**HYUNDAI**NEW THINKING.
NEW POSSIBILITIES.**Technical Service Bulletin**

GROUP	NUMBER
EMISSION CONTROL	12-EC-001
DATE	MODEL
OCTOBER 2012	ELANTRA (MD)

SUBJECT: FRONT MUFFLER RATTLE NOISE IN REVERSE WHEN COLD*This TSB supersedes TSB 12-AT-003 to revise the Service Procedure*

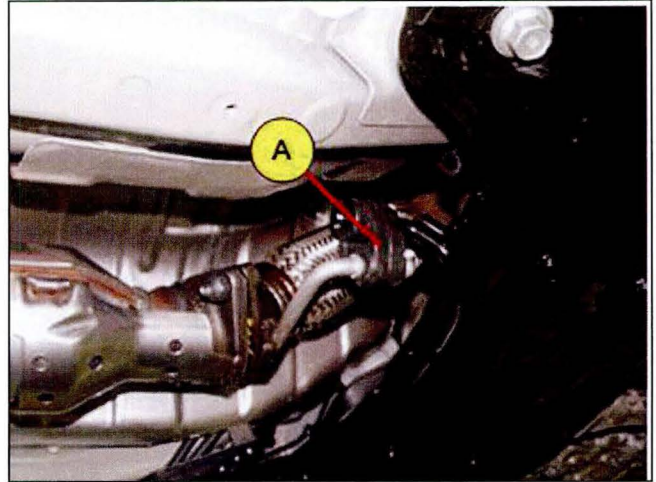
1. Lift up the vehicle on a hoist and locate the front hanger of the front muffler (A).

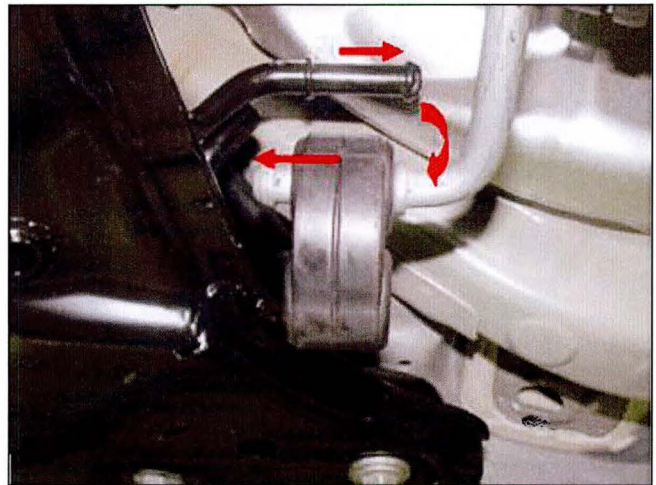
2. Remove the front hanger of the front muffler.

Pull the upper hole side of the front hanger off the nipple (black), then remove the hanger.

3. Install the new front hanger in reverse order of removal.
